CITY OF SAUSALITO

Addendum No. 2

Notice Issued March 27, 2014

For: Sausalito Fishing Pier Repair Project

Bid Alternative
to Details F & G on Sheet S1.1
Addendum 2
3-27-14

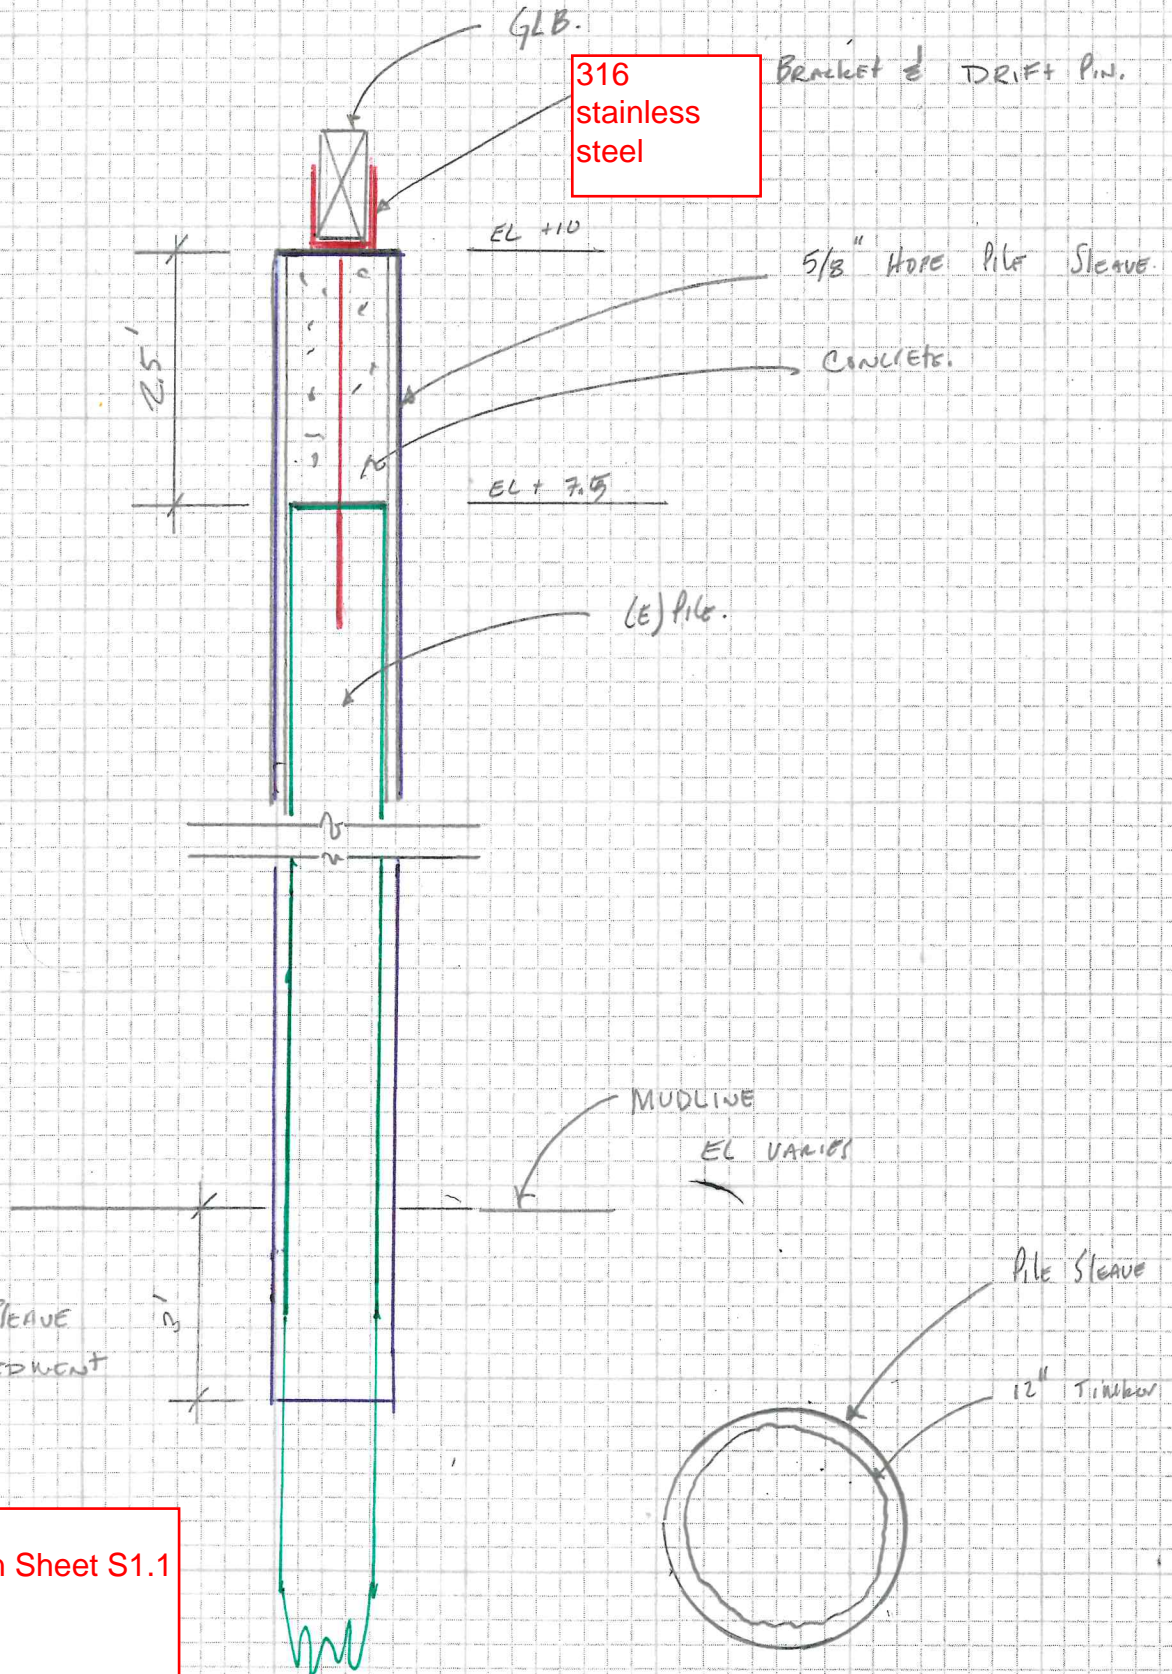
- b. Fender piles are not to be wrapped.
5. Sheet S1.1 Bid Alternative to Details F & G on Sheet S1.1
 - a. Attached Detail shall be bid as an alternative to details F and G on Sheet S1.1
